Thameside West

Energy and Sustainability Statement

Addendum

May 2020

Figure 2—17 the detailed PV layout for the roofs of plots A and B as based on the optimisation

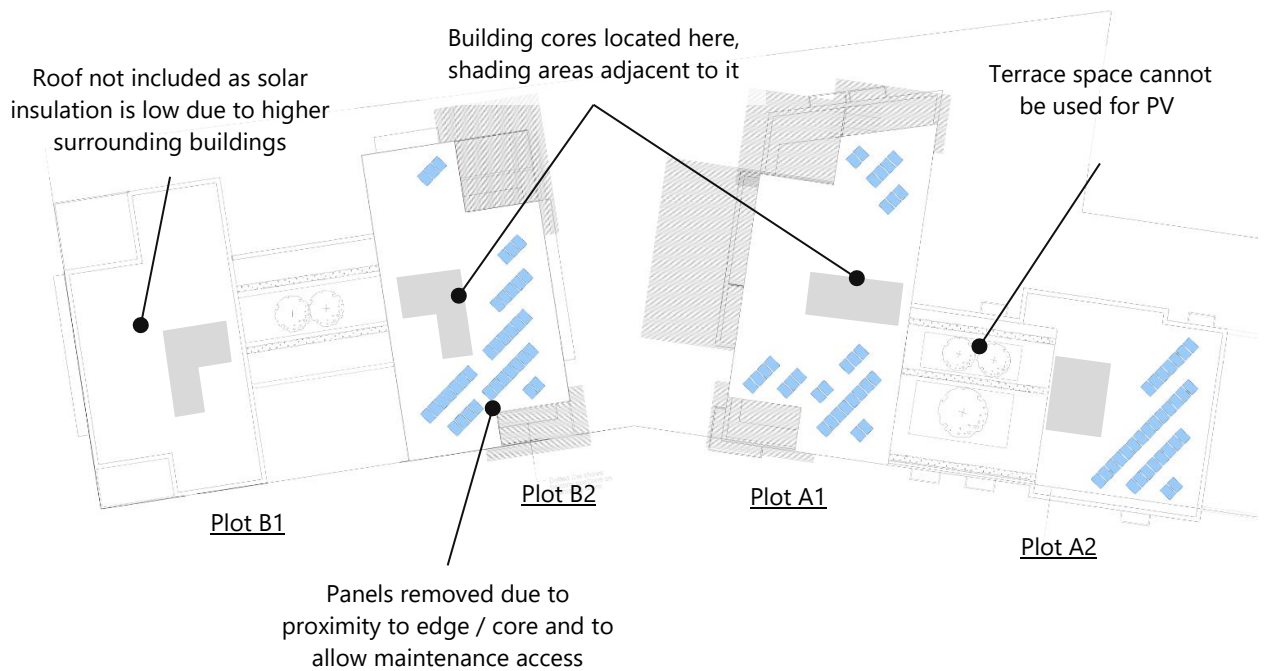
37. 25kWp of PV is being proposed for Phase 1, and 197kWp is proposed for the Phases 2-12 as included in the outline application. The applicant should confirm the proposed net PV areas. It appears that there might be additional space available for PV. A detailed roof layout should be provided demonstrating that the roof's potential for a PV installation has been maximised; they should outline the solar insolation and any other constraints. The applicant is required to maximise the on-site savings from renewable energy technologies, regardless of the London Plan targets having been met, and therefore the PV proposals should be reviewed.

The suggested PV placement is generated by a computer optimisation based on angle, spacing, tilt and direction. This is done in order to ensure that all the suggested PV panels are highly performing, and to maximise the energy output for each roof throughout the day. Figure 2—16 shows that the applicant could increase the amount of PV panels across the

roofs, but also that not all panels would be working efficiently, which could potentially affect the overall performance negatively. Figure 2—17 shows the detailed roof layout as suggested by the computer optimisation.
